Subject: Bid Package #1
Borel Middle School HVAC Replcmt-DSA 01-119557
College Park Elementary School HVAC Replcmt-DSA 01 119530
Meadow Heights Elementary School HVAC Replcmt DSA 01-119554
North Shoreview Montessori School HVAC Replcmt DSA 01-119526
San Mateo - Foster City School District

ADDENDUM NO. 1

Subject: Borel Middle School HVAC Replacement
San Mateo - Foster City School District
Aedis Project No. 2021005
DSA Application #01-119557

ADDENDUM NO. 1

DATE 11/24/2021
JOB # 2021005.07
SHEET # AD1-
A3.02

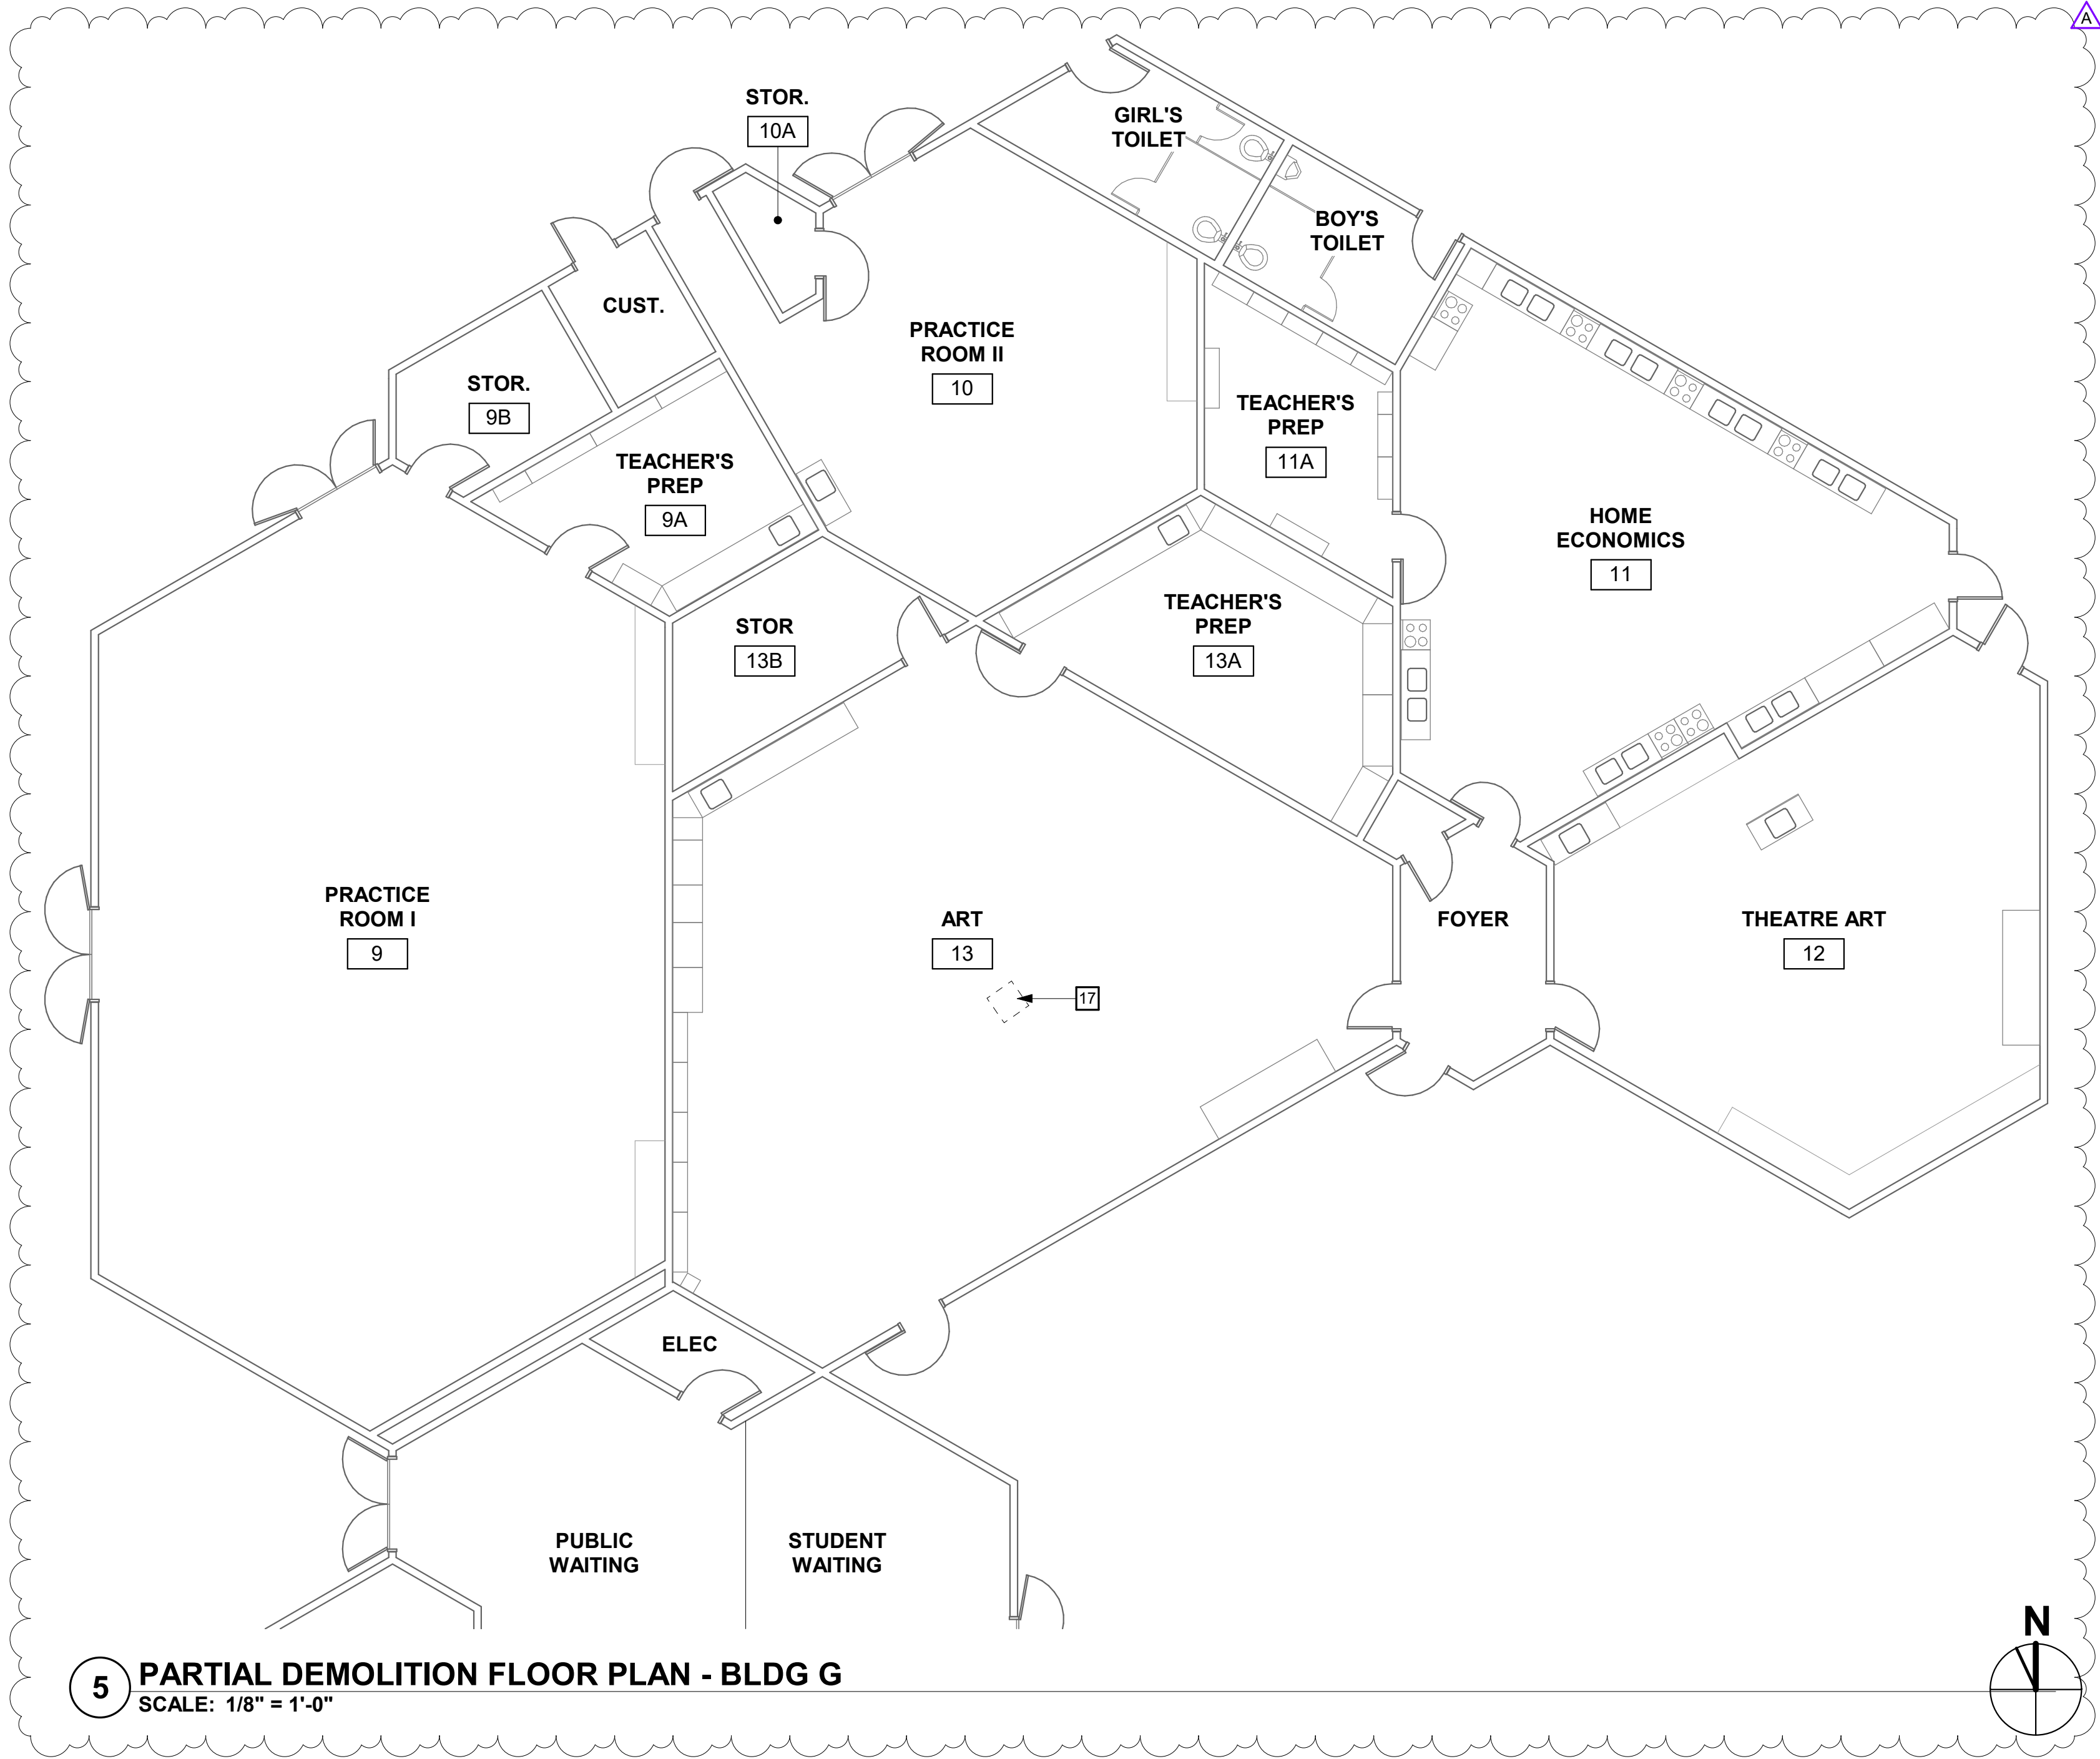
- Add: View 5/A3.02 New Partial Floor Plan – Bldg. G per AD1-A3.02
- Add: New Floor Plan & RCP Keynote #17 per AD1-A3.02

SHEET # AD1-
A5.01

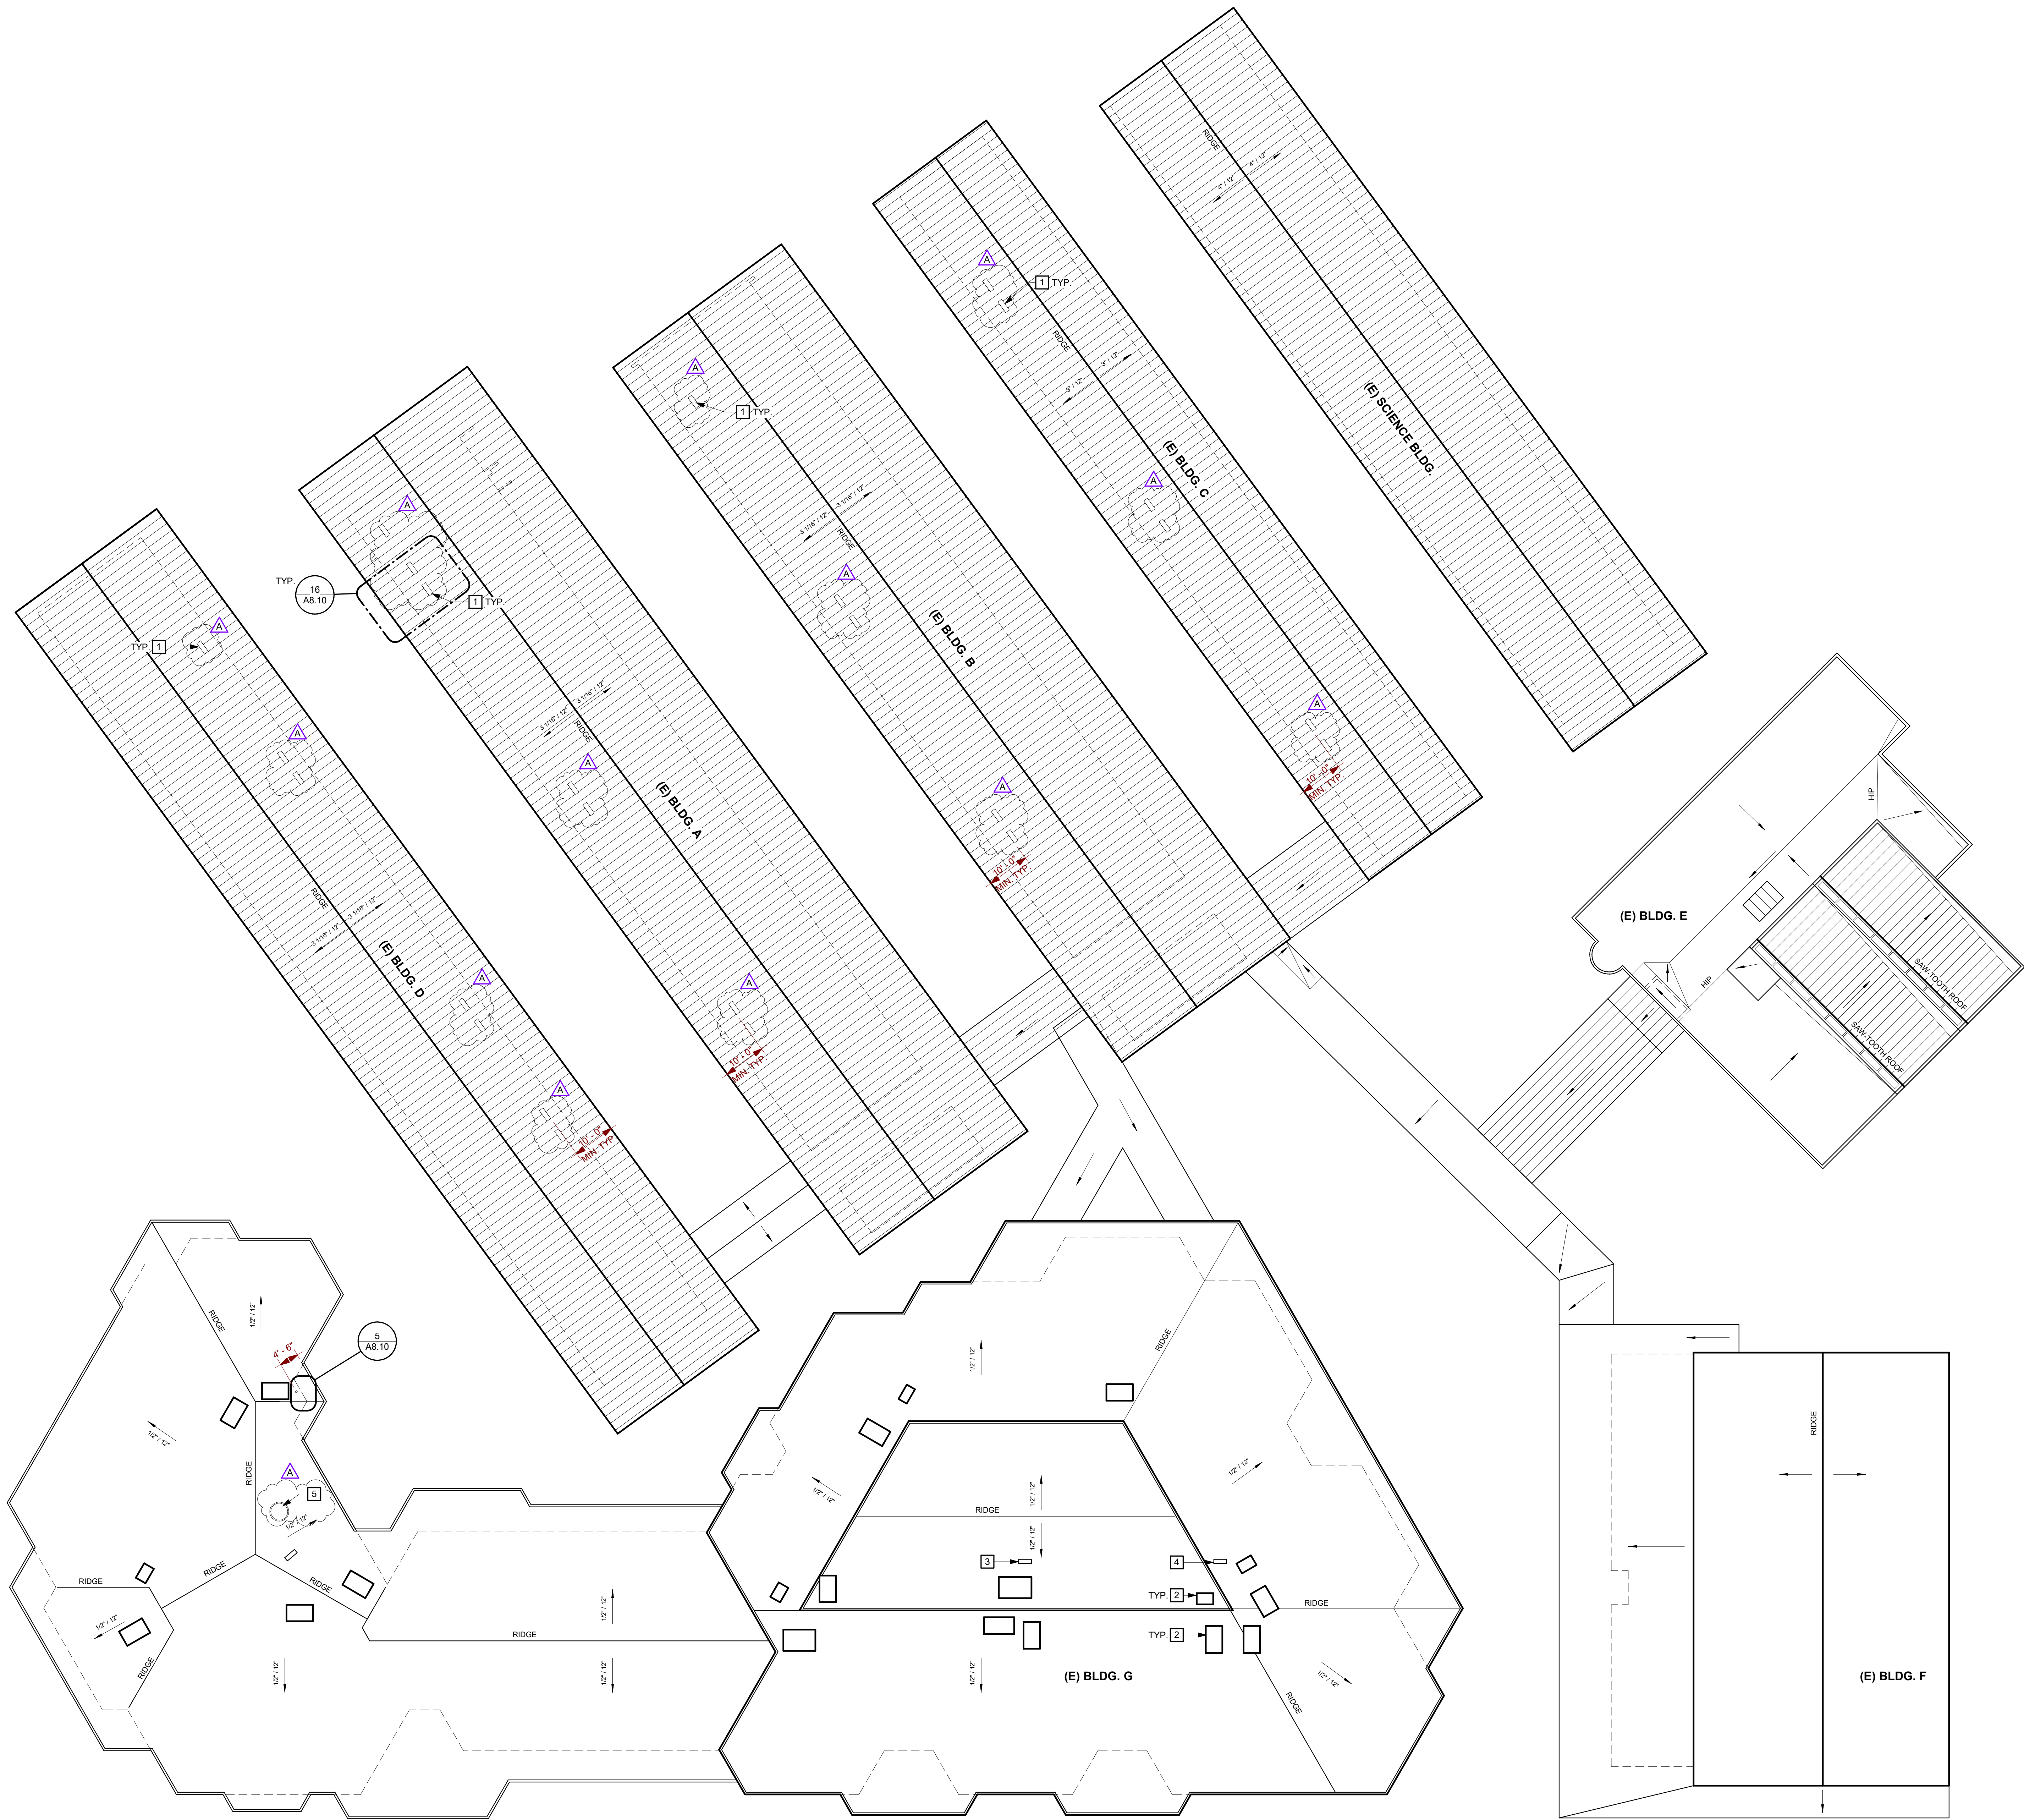
- Add: Exhaust fan per AD1-A5.01
- Revise: Mechanical platform graphic per AD1-A5.01
- Revise: Roof Plan Keynotes #1 and #2 per AD1-A5.01
- Add: Roof Plan Keynote #5 per AD1-A5.01
